This will record our telephone conversation with you on April 28 regarding our subsurface investigation report No. SF-854 for the proposed new bridge near Ste.-Anne de Prescott.

United Counties of Prescott and Russell,
Bridge over the Rigaud River,
Township of East Hawkesbury,
Lots 10/11, Con. VI/VII,
Structure Site No. 27-158,
Your File No. BA 2034

The above report by the Soils Consultant, McRostie, Seto Genert and Associates Ltd., has been reviewed and subsequently discussed with the Consultant. The following comments are submitted for your consideration:

STABILITY ANALYSIS
AT EAST ABUTMENT
EAST HAWKESBURY TOWNSHIP

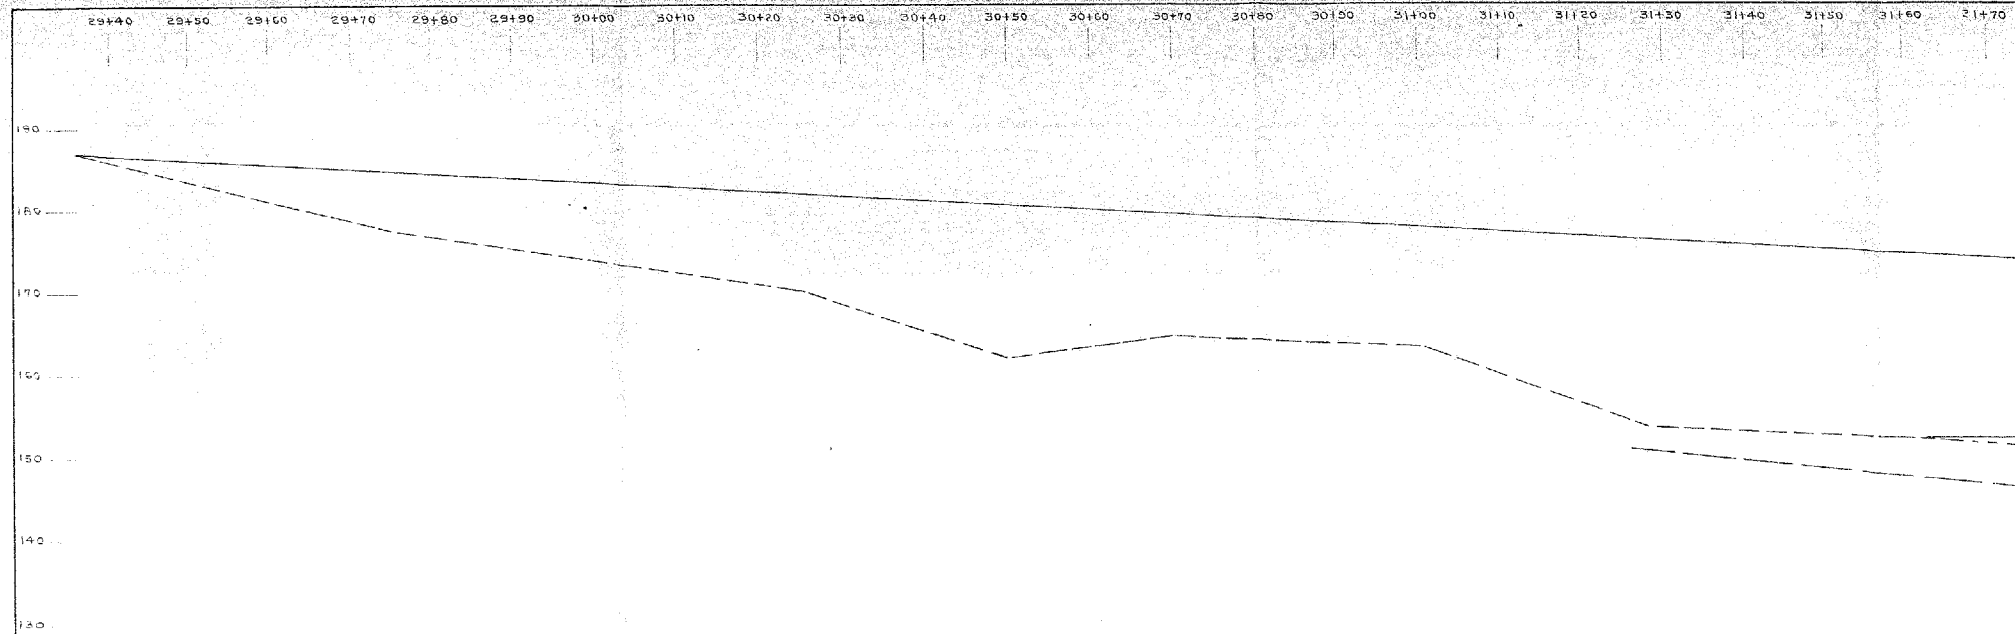
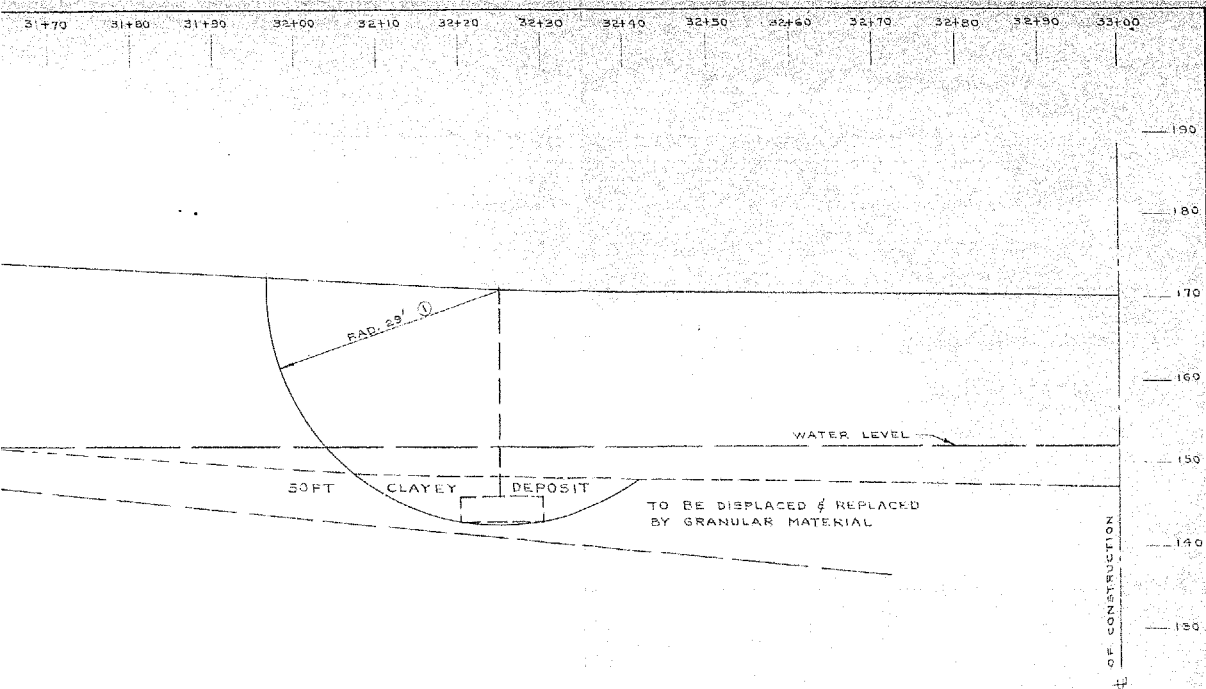
In section 2.2.1 of the report we suggested that an embankment material possessing stress-strain characteristics similar to the underlying deposit be used in order that the shear strength of the east embankment material could be developed to resist failure. Thus it was felt that a clay embankment should be considered. However, in the last paragraph of this section it was pointed out that a granular fill would need to be placed at the contact area between the clay embankment fill and the abutment; this of course, to avoid the larger pressures on the abutment associated with a clay backfill.

1. Piled Foundation: Steel H-piles driven to bedrock or practical refusal, should be considered if found to be more economical than Franki or similar type of piles. Unfortunately, the length of H-pile cannot be estimated accurately as bedrock was not proven in B.H. 1 and 2, but should be of the order of 30 ft. according to B.H. 3.
2. The soft material at the west approach embankment should be removed. If displacement method is used, sufficient time should be allowed to elapse before paving so that the trapped material may consolidate.
3. In no case should clay backfill be used behind the abutment. The standard D.H.O. requirements for back-filling should be adhered to.

The clay fill would exert pressures on the new bridge abutment; we recommend that granular fill be placed at the contact area between the clay embankment fill and abutment.
